ADDENDUM NUMBER 3

Project Number 89008230

Project Title NW 72nd Street Improvements
Federal STP-3451(401)

ISSUE DATE: 12/27/2018

PAVEMENT MARKING
AND SIGNING PLAN
1 OF 3

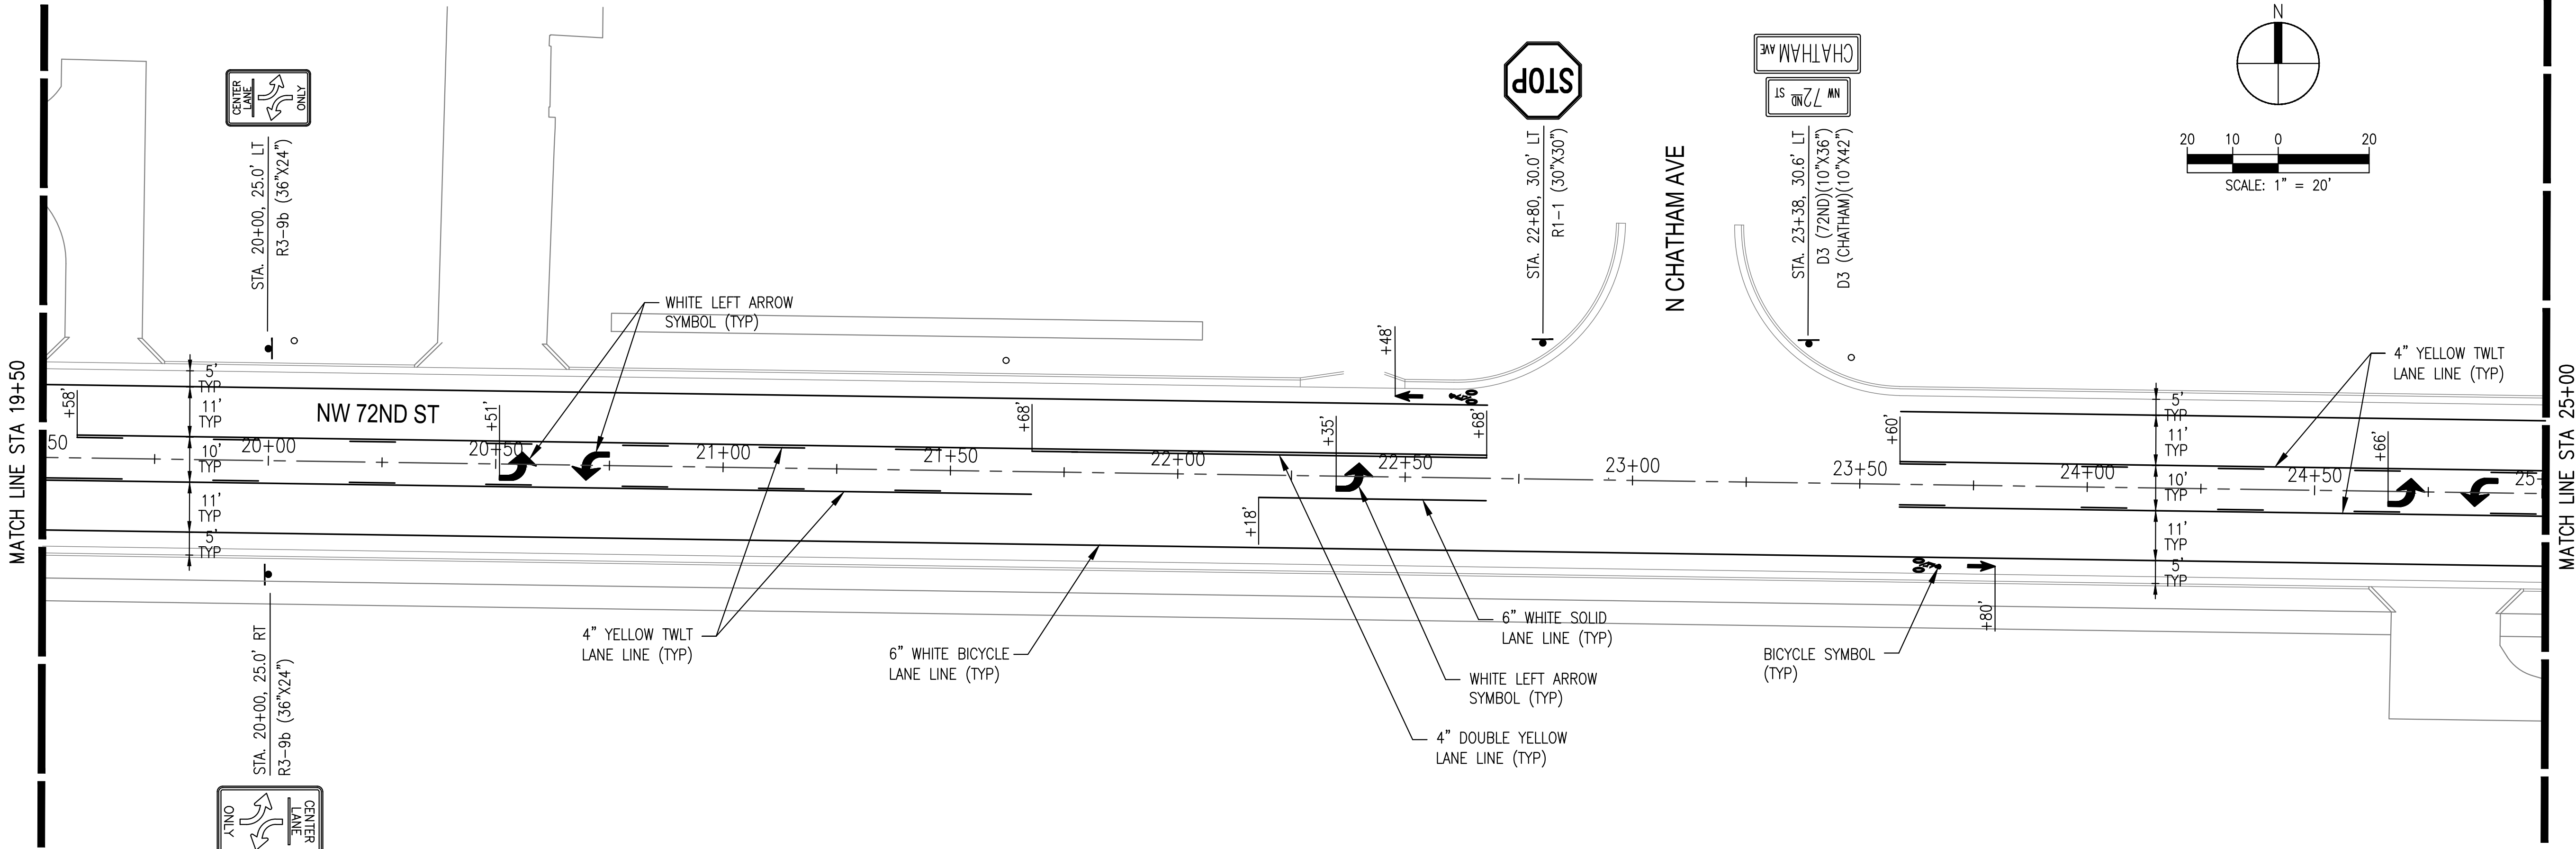
1. Revise the proposed pavements markings to include on-street bike lanes and roundabout signing update as shown on Addendum #3 drawings. Updated sheets include quantity sheet, typical sections, plan and profile sheets, and signing and pavement marking sheets.
2. Remove details 10 and 11 on sheet 057 from the plan set.
3. Replace section 00412 Unit Prices in the Project Manual.
4. Add Variable Message Signs to list of Bid Item descriptions (JSP V) in the Project Manual.
